SUBJECT: Millstone Creek Mitigation Site - NCIRT Comments during 30-day Mitigation Plan Review

NCDMS Project Name: Millstone Creek Mitigation Site, Randolph County, NC

USACE AID#: SAW-2019-01363

NCDMS #: 204

Figure 10.1: Millstone Creek Site Mitigation Monitoring Plan

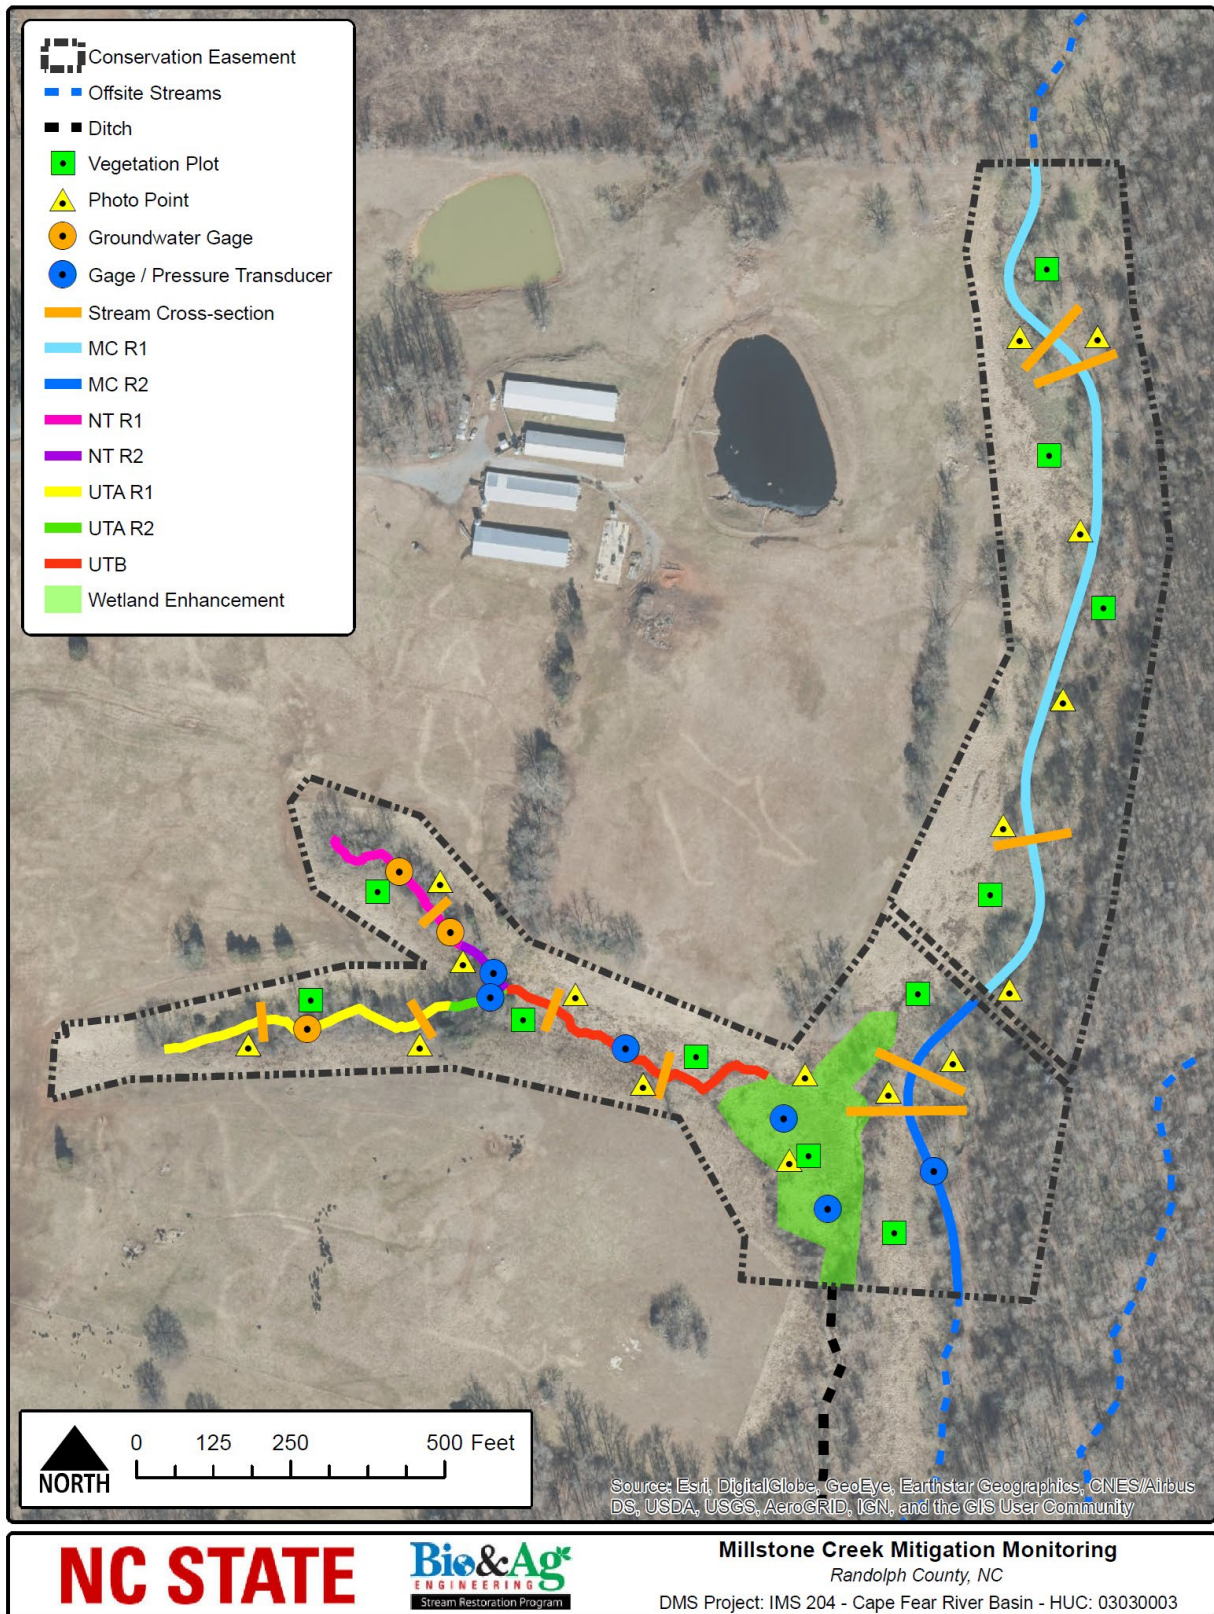
12. Figure 10.1
 - a. In order to monitor the minimum 30-day consecutive flow performance standard, please add flow gauges to NT R1 and UTA R1, within the upper one-third of each reach. **Gauges have been included in these locations on the monitoring map.**

- b. DWR requests an additional cross section along the lower section of MC R1 and an additional wetland groundwater gauge. **An additional cross section has been added in this area.**

- c. Please show the easement boundaries. **The easement boundary has been included on maps and plan sheets.**

Figure 10.2: Millstone Creek Site Supplemental Monitoring Plan

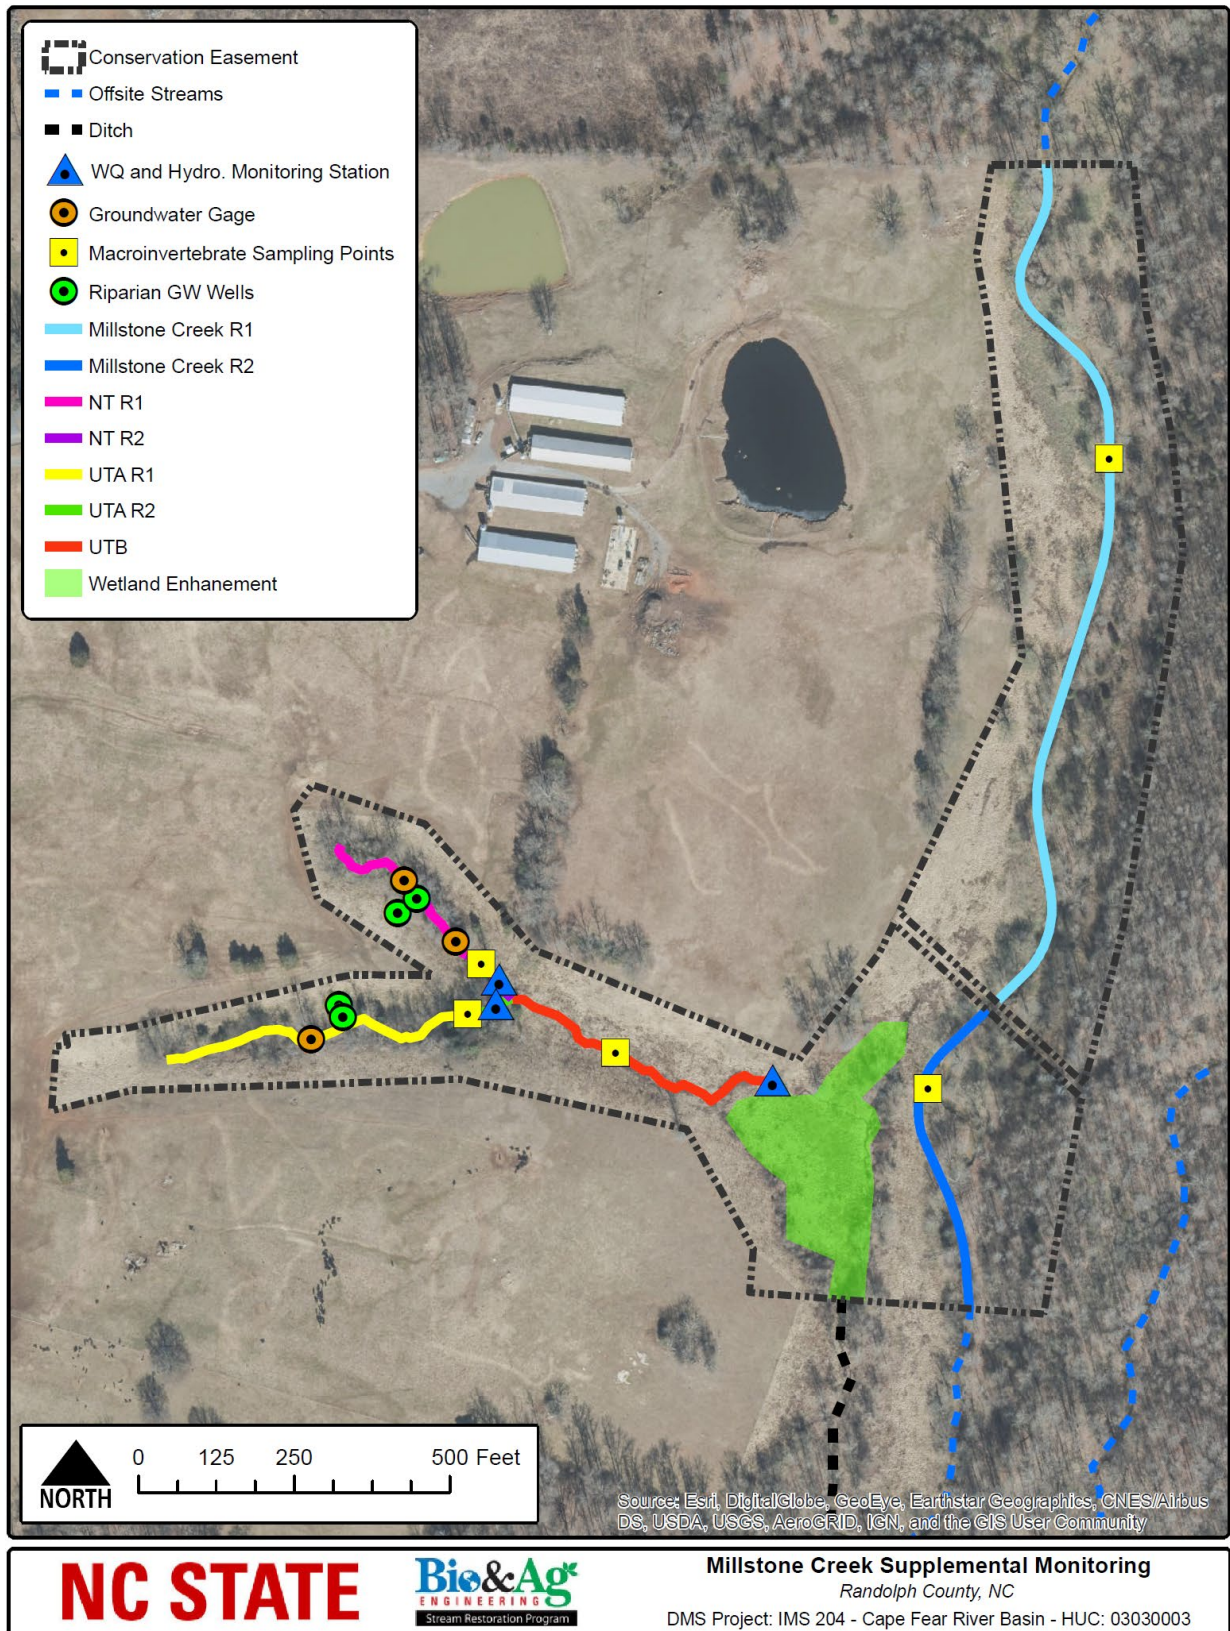
9. Please include the water quality monitoring locations on the Monitoring Map. **Water quality monitoring stations have been included in figure 10.2 Supplemental Monitoring Map.**

**DITCH FILL
DETAILED PLAN AND PROFILE VIEW**

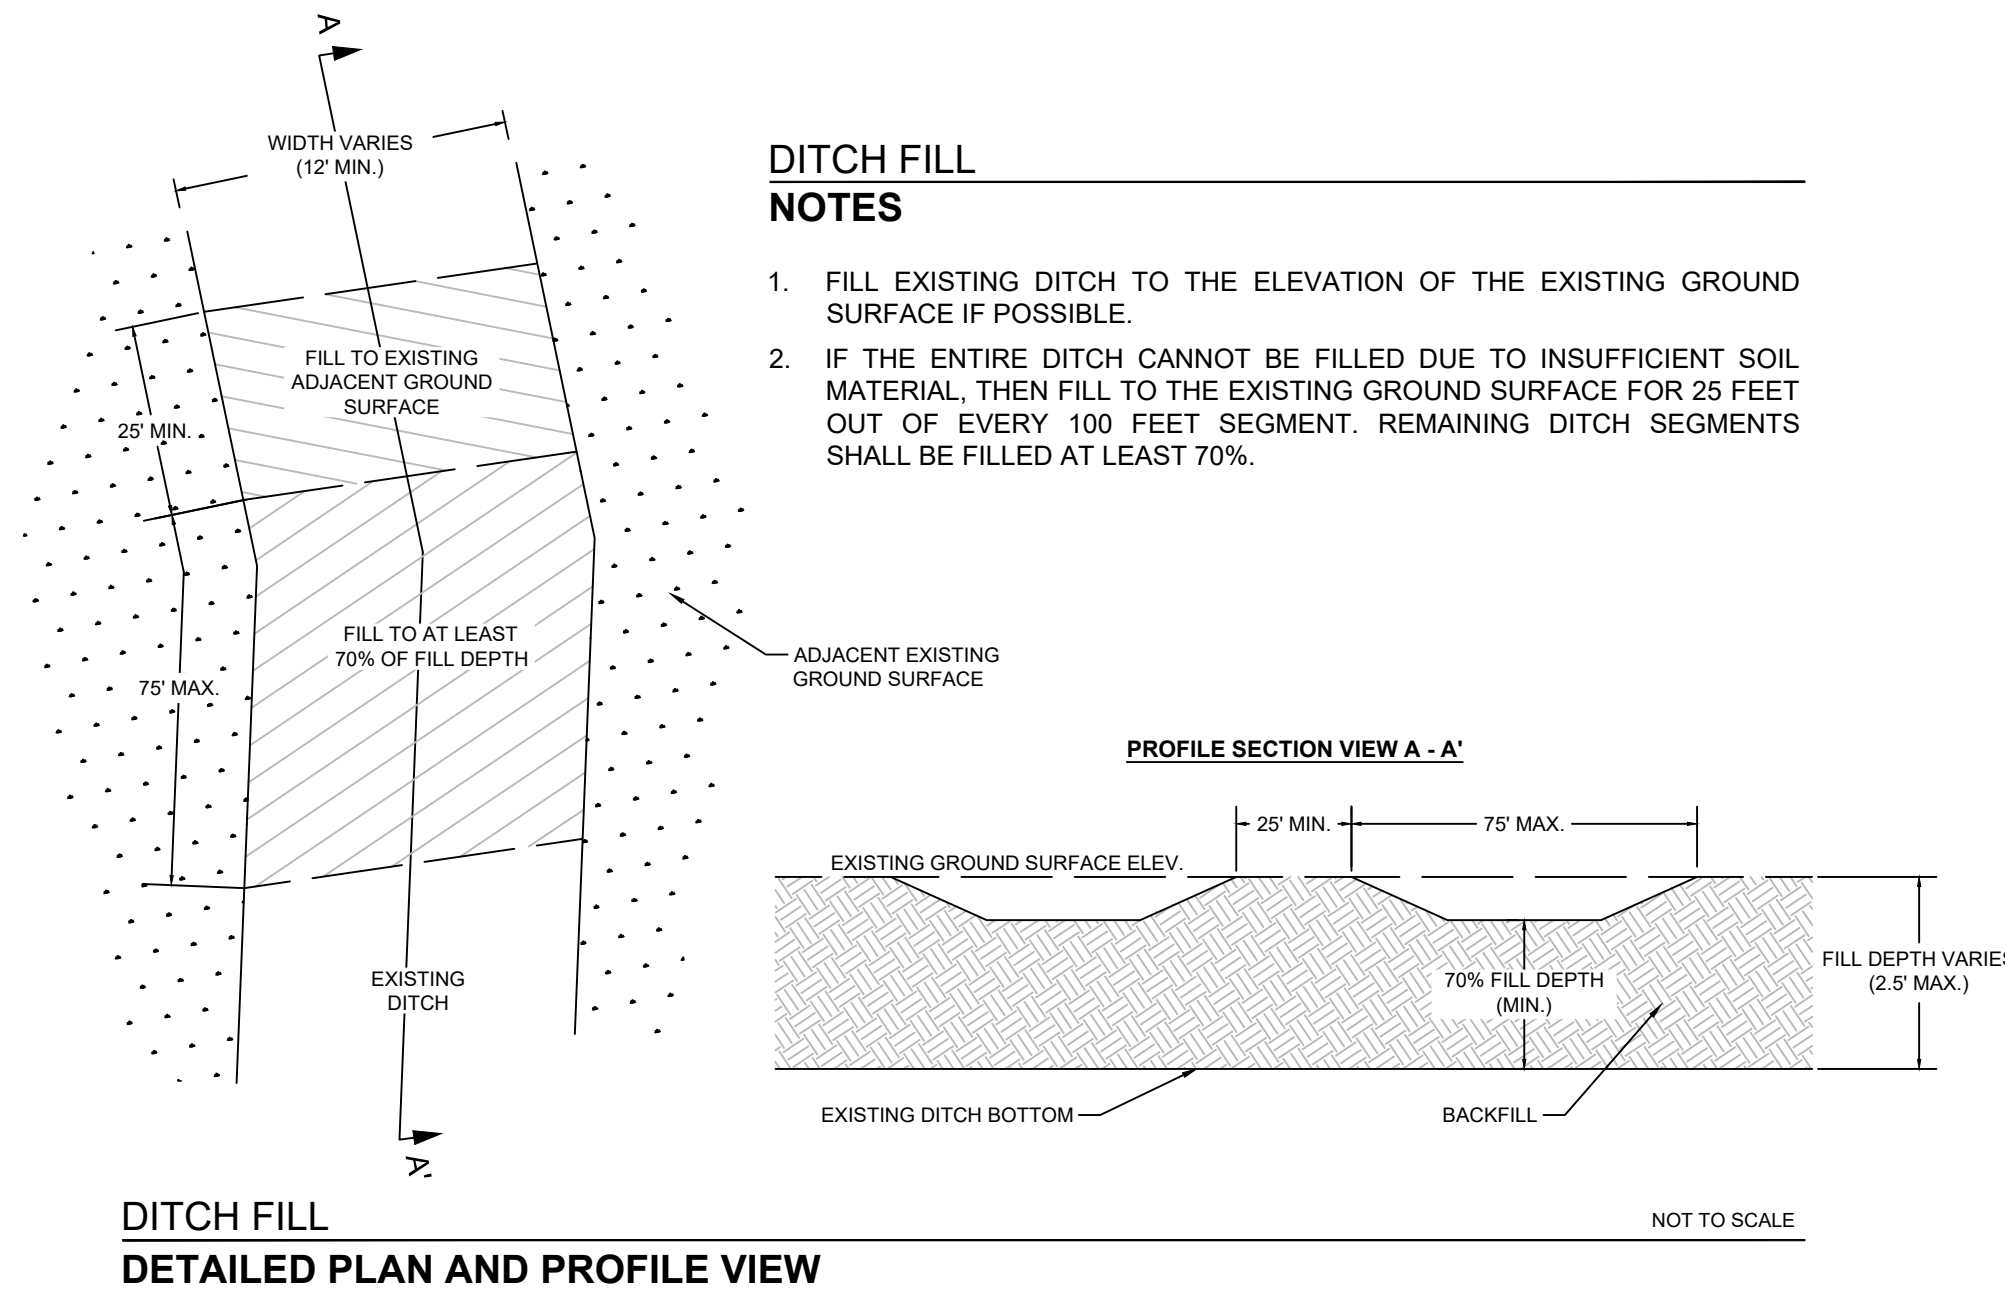
- a. Please include a ditch plug detail. **A ditch plug detail has been included in the plan sheets.**
14. There is concern for hydrologic trespass to occur since the ditch entering the wetland will be plugged and there is no planned outlet for the wetland. **Site topography limits hydrologic trespass potential to the southern easement boundary. The site will be monitored for hydrologic trespass on the southern boundary of the easement between phase 1 phase 2 of the project and if necessary a remediation plan will be developed and implemented during phase 2.**

**PERMANENT FORD CROSSING
DETAILED PLAN**

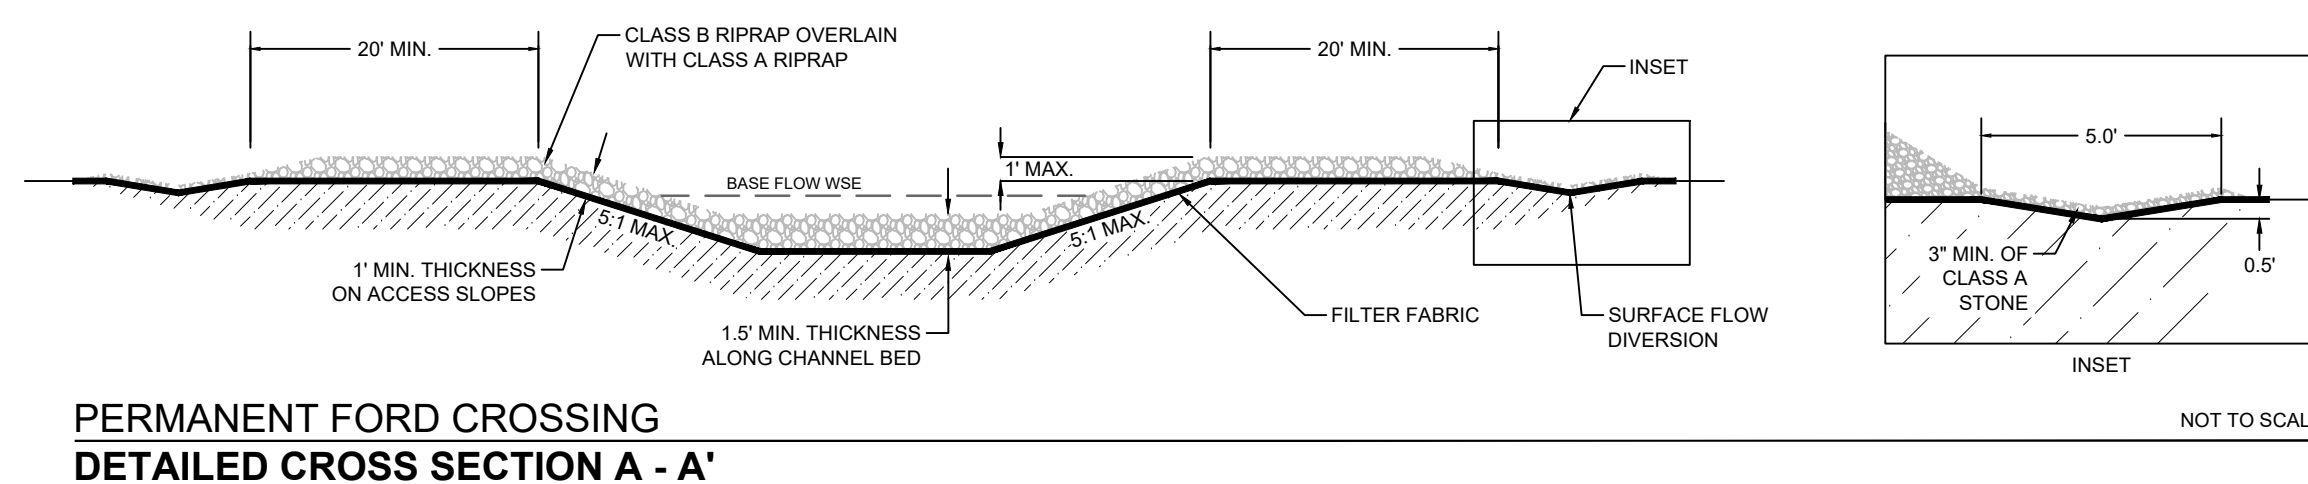
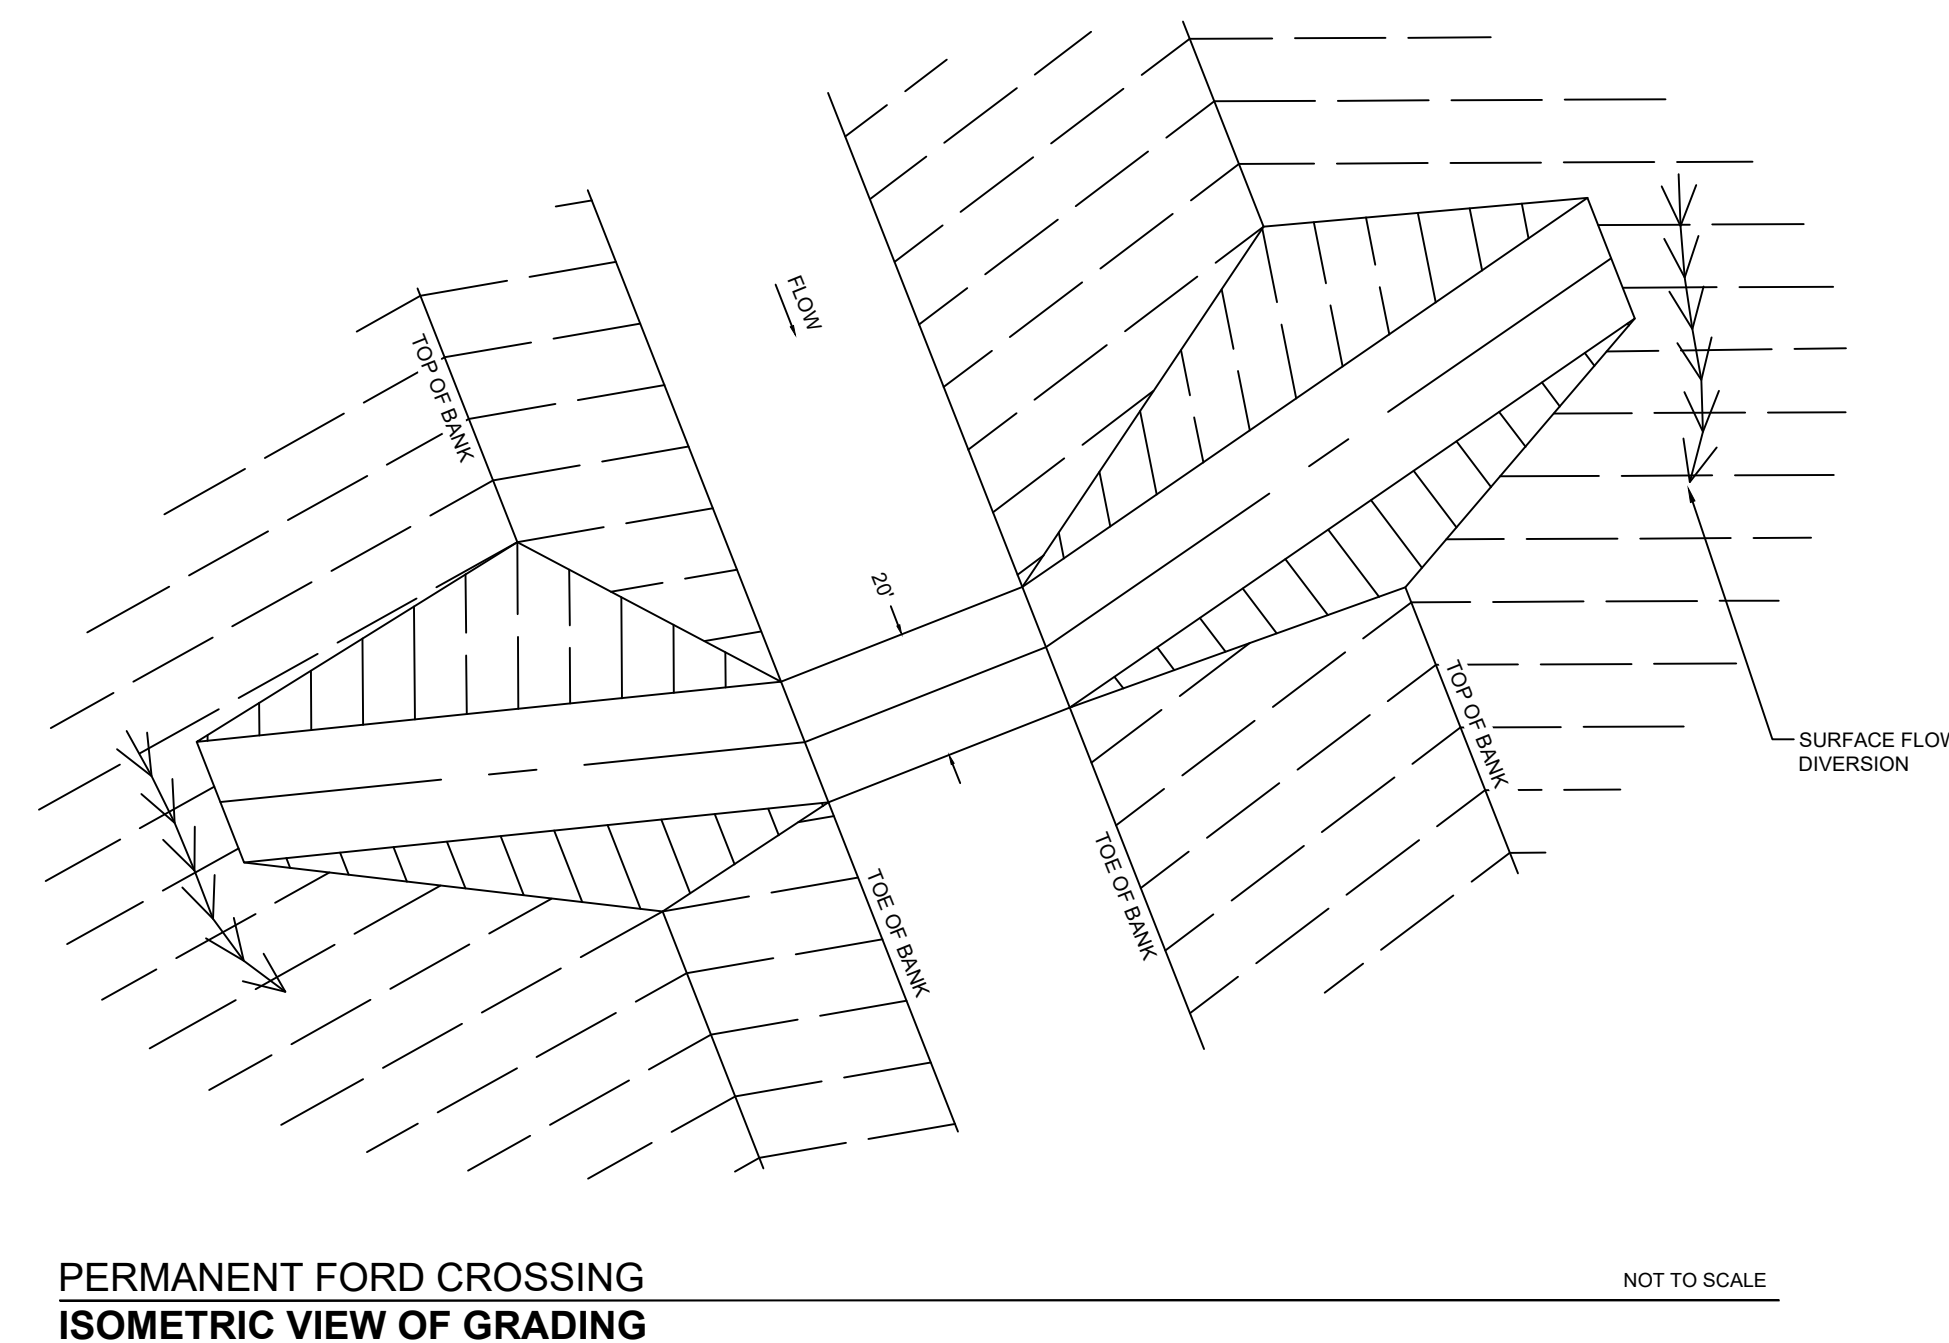
16. Ford Crossing: There is some concern with the amount of sediment coming into the system. Without seeing the design detail it's difficult to discern whether the structure will have an upstream and downstream sill to hold elevation and retain substrate in place. Will it be designed to incorporate reinforcing underlying material? **Sediment load has been considered in the design for the project, both on and off-site sources are being addressed. A ford detail has been included in the plan sheets.**
